Exhaust Band Clamp Torque CHU, CXU, TD

PI0829, Exhaust Band Clamps Torque

(August 2013)

W2083859

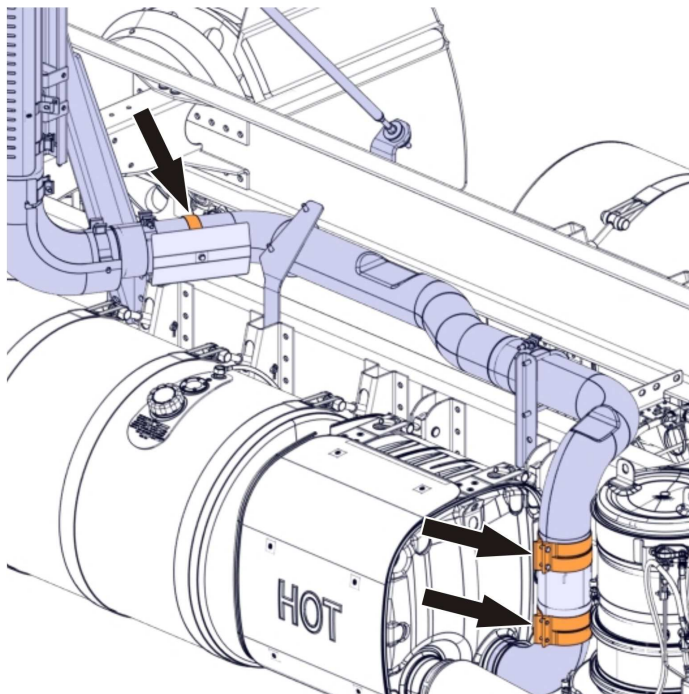
The aftertreatment selective catalytic reduction (SCR) outlet pipe band clamps and heat shield fastener on certain MACK vehicles built between June 28, 2013 and July 23, 2013 were not torqued correctly. Follow the procedure below to tighten the fasteners to specification.

- 1 Secure the vehicle for service by parking it on a flat level surface, applying the parking brake, chocking the rear wheel, and placing the transmission in neutral.
- 2 Tighten SCR outlet pipe hose clamps to 70 ± 10 Nm (50 ± 7 lb-ft) and tighten heat shield band clamp to 55 ± 5 Nm (40 ± 4 lb-ft)..
